DEVIATION REQUEST AND DECISION FORM

Project Name : Monument Ridge East

Deviation Request from ECM 2.3.2 -- Design Standards by Function Classification

Intersection Spacing Along an Urban Major Collector

Deviation No. 1 - Exhibit 1

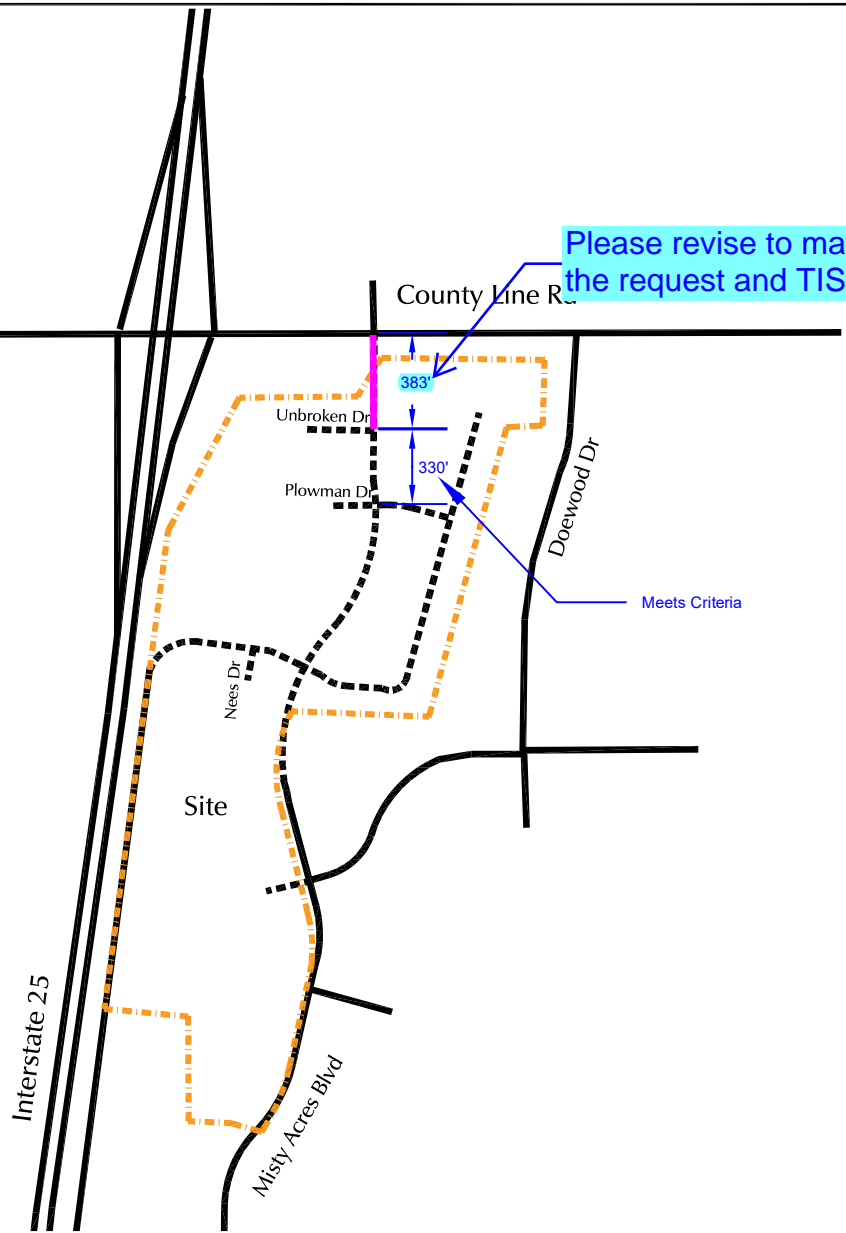
Please clarify if section C is being deviated from; not listed below

Please add the sight distance figure from the TIS as an exhibit

As the adjacent intersection to the north is an Arterial (County Line Road), the standard requires an intersection centerline spacing of 660 feet. Centerline spacing on Misty Acres Boulevard between County Line Road and the Unbroken Drive would be 390 feet (see Deviation Exhibit 1).
